Agenda
HAILEY PLANNING & ZONING COMMISSION
Monday, March 30, 2020
Virtual Meeting
5:30 p.m.

PH 1 Consideration of a Preliminary Plat Subdivision Application (Phase I) by Sweetwater Communities, LLC, represented by Matt Watson, located at Block 2, Sweetwater P.U.D. Subdivision, where Phase I of Block 2 is subdivided into 14 sublots consisting of seven (7) live-work units, one (1), ten-unit condominium and two (2), three-plex townhomes for a total of 23 residential units. This project is located on the corner of Shenandoah Drive and Countryside Boulevard within the Limited Business (LB) Zoning District. **ACTION ITEM**

STAFF REPORT
Hailey Planning and Zoning Commission
Regular Meeting of March 30, 2020

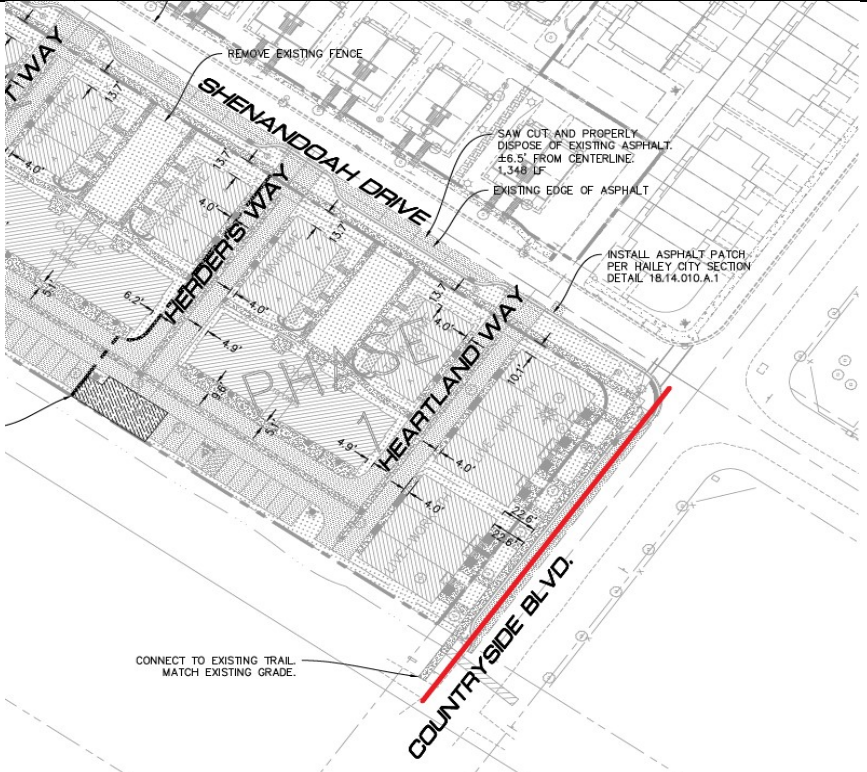
| | | | <p>Staff Comments</p> | <p>A new five (5') foot-wide sidewalk is proposed along the perimeter of the proposed project. This sidewalk will run parallel to Shenandoah Drive, approximately 600' in length, before curving to the east and crossing Shenandoah Drive (continental crosswalk, which utilizes thermoplastic materials). This sidewalk will connect to existing pathways found near and around the park space and amenity building.</p> <p>Pedestrian connections are also shown at the northwestern end of the parcel, connecting to the Wood River Trail, and from the Wood River Trail to Shenandoah Drive (see image below for further details).</p>  <p>A second connection is also proposed from the public sidewalk on the north side of Countryside Boulevard to the Wood River Trail (see image below for further details).</p> |

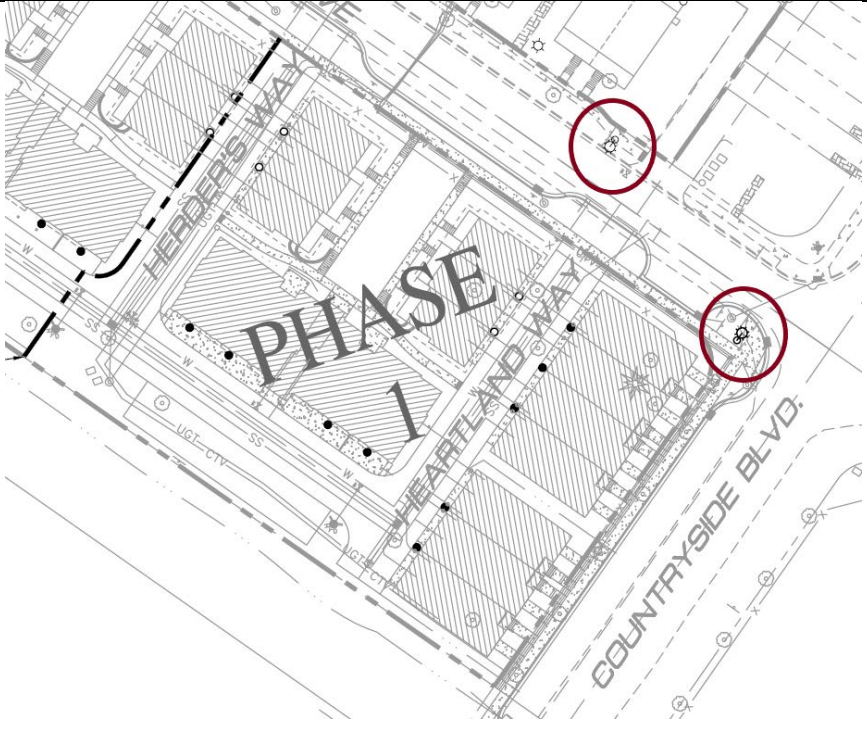
| | | | Staff Comments | Two (2) street lights are proposed within Phase I of the development (see image below for further details). |
| | | | |  <p><i>All street lights will be maintained by the Sweetwater Homeowner's Association and all infrastructure will be approved by the City prior to construction. All construction must conform to City of Hailey Standard Drawings, Specifications and Procedures.</i></p> |

L1.0
LANDSCAPE PLAN

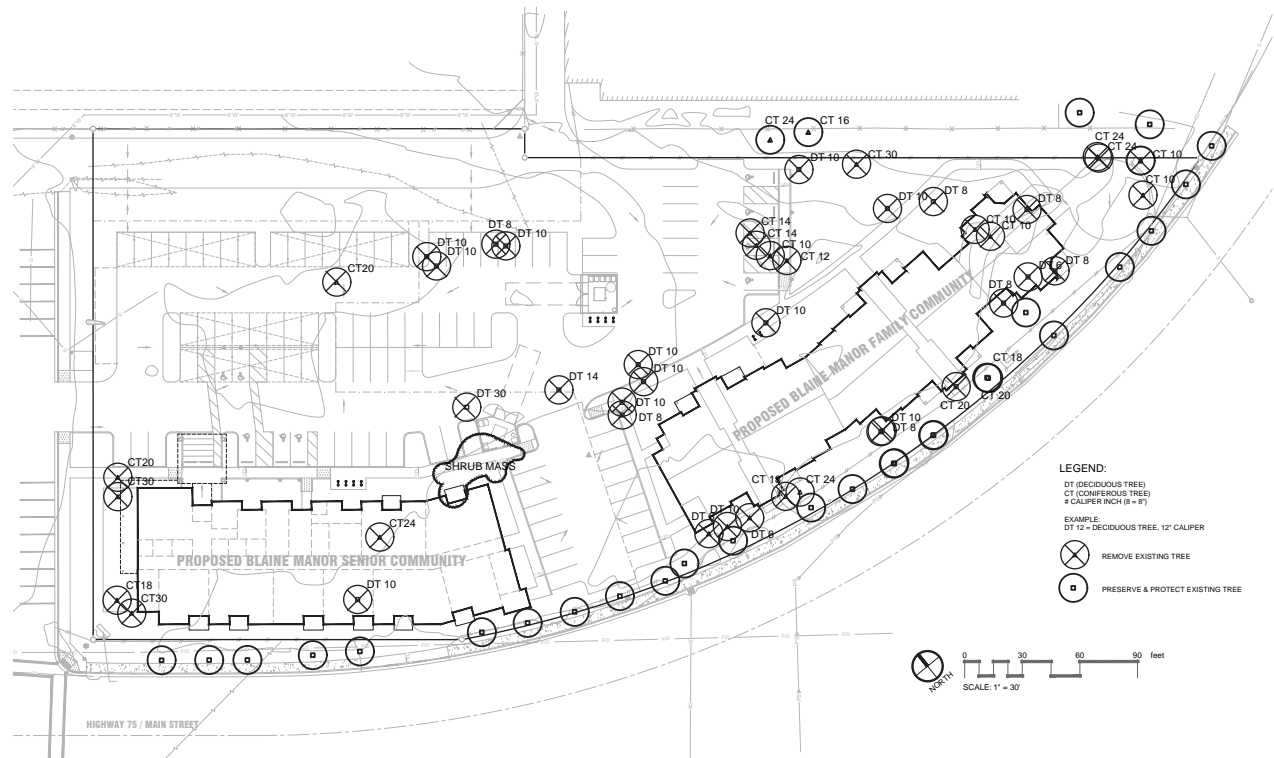
| | | | | <p><i>consider retaining as many of the existing trees as possible. Revised Landscape Plans have been submitted (Sheets L1.0 and L1.1), which show several trees to be removed, protected and/or new trees to be planted. Approximately 43 trees are proposed to be removed. Several of the proposed trees to be removed are larger than six (6") inch caliper; thereby requiring an Arborist Review.</i></p> <p><i>Please refer to Section 17.06.080(A)1b for further details and information regarding the Arborist Review.</i></p> <p><i>Additionally, the Hailey Tree Committee is scheduled to meet and discuss the project on March 12, 2020. Additional comments from the City Arborist and the Hailey Tree Committee, including any recommendations made, will be brought to the hearing on March 16, 2020.</i></p> |
